UNITED STATES PATENT AND TRADEMARK OFFICE

Office Action Summary	Application No.	Applicant(s)	
	10/797,909	SALZER, HEINRICH	
	Examiner	Art Unit	
	Branon C. Painter	3609

DETAILED ACTION

FIG. 1

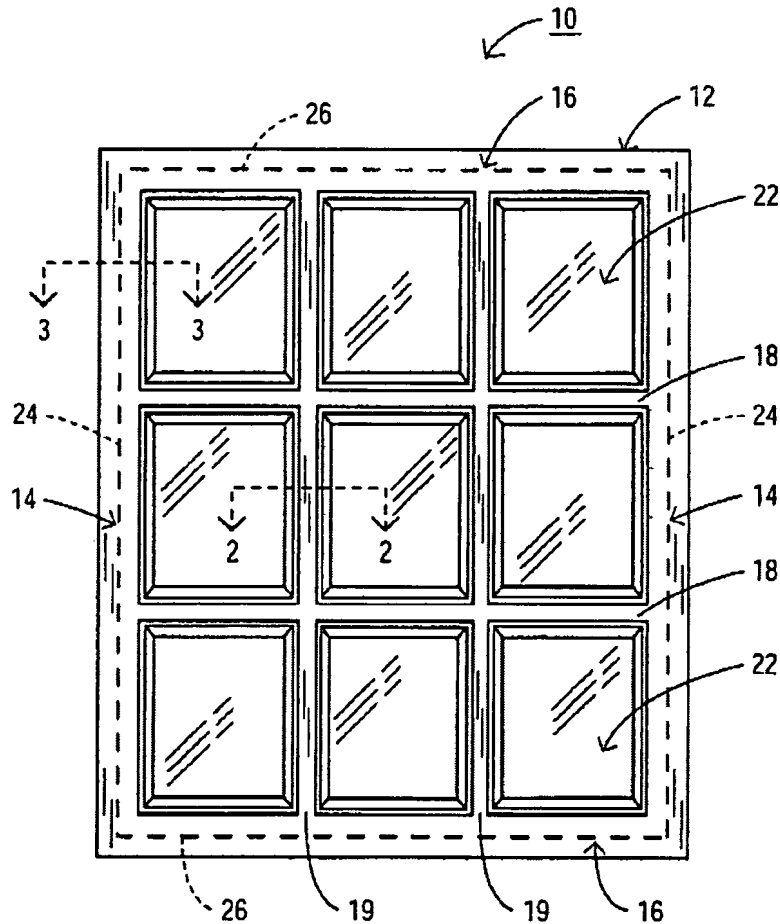
- a. Eichhorn discloses a cover element for the opening of a building, including:
 - i. "Two mutually opposite visible sides which are each provided with a plurality of glass fields..." (Figure 1).

- ii. "...which are each delimited by regions made of a metallic material..."
(Figure 1; "the simulated muntins may be...metal", column 4, lines 18-19;).
- iii. "...between which a glass pane is arranged which extends substantially over the entire surface of the sheet-metal plate..."
(Figure 1).
- iv. "...with the glass fields each having a size which prevents the penetration by persons, with the glass pane and the sheet metal plate being arranged within frame elements enclosing the cover element in circular fashion..." (Figure 1).

Reproduced from U.S. Patent No. 5,487,245

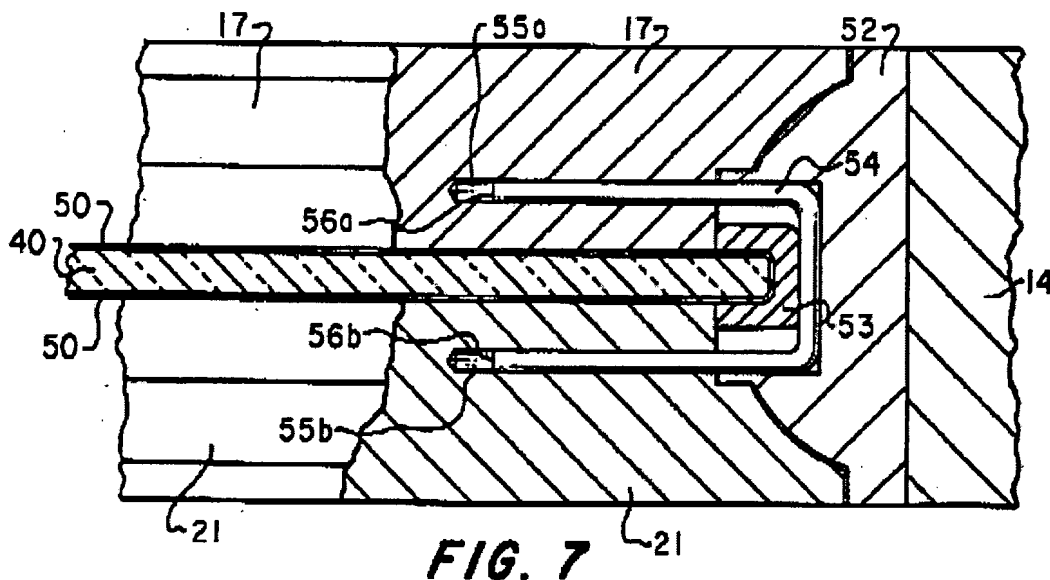
- c. Dazo discloses a sheet metal plate ("front muntin" 21, "back muntin" 17, Figure 7) facing a web of a frame leg ("stile trim" 52, Figure 7). The sheet metal plate projects on the edge side beyond the glass pane (Figure 7) [claim 3]. Dazo also discloses a glass pane ("unitary light transmissive sheet" 40, Figure 7) clamped between the sheet metal plates [claim 5].

Fig. 3

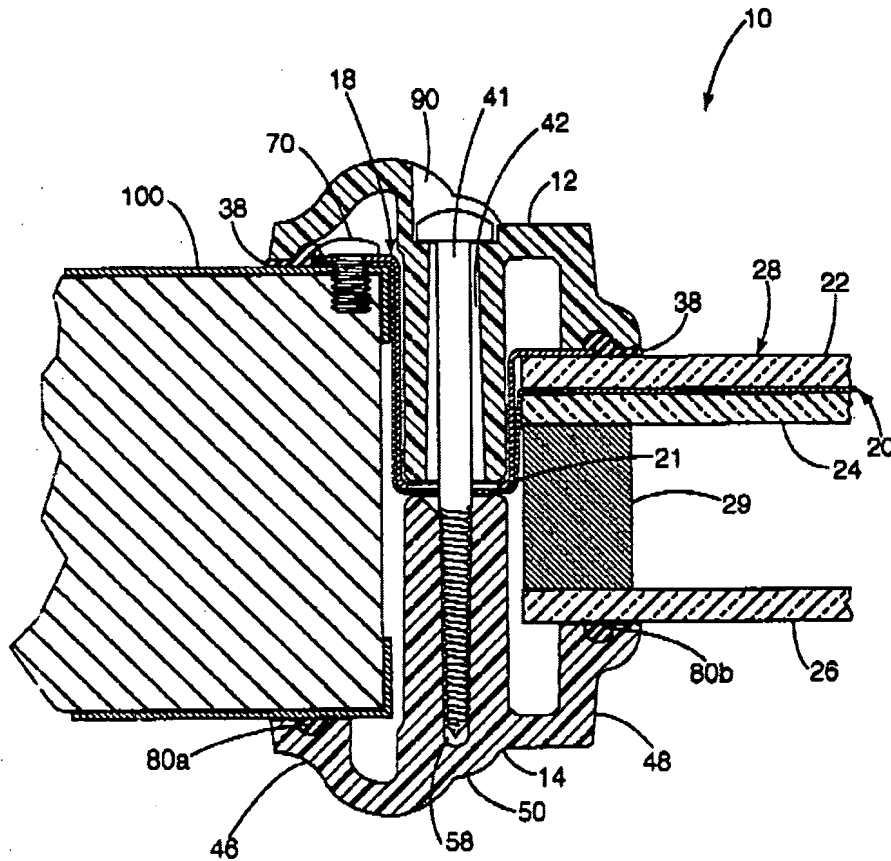
- c. DeBlock et al. discloses a sheet metal plate (outside edges of "door" 100, Figure 3) resting on a web ("door-engagement flange" 46, Figure 3) projecting into the cross section of the respective frame element [claim 6]. A sealing profile ("gasket" 80a, Figure 3) is arranged between the sheet metal plate and frame element web [claim 7].

FIG. 2A

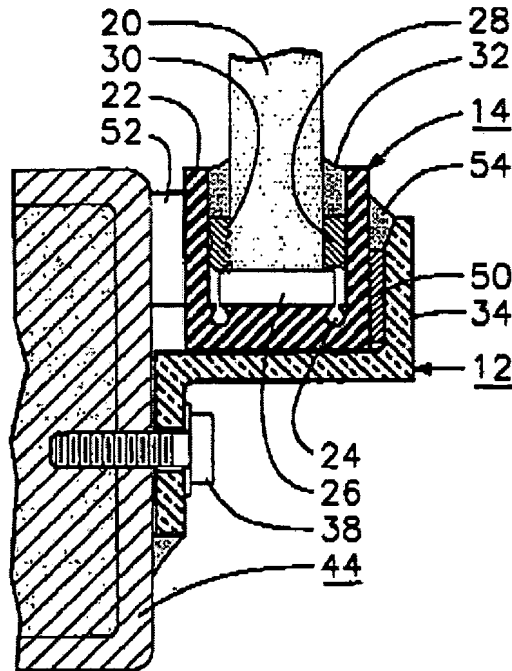
- c. Huynh discloses a gasket ("glazing gasket" 32, Figure 2a) serving as an intermediate between a glass pane ("glass pane" 20, Figure 2a) and a metal plate ("glazing frame" 14, Figure 2a; "A glazing frame 14 is also made of a metal or other suitable material," column 2, lines 50-51). The use of the intermediate gasket provides the assembly with a water-tight seal.
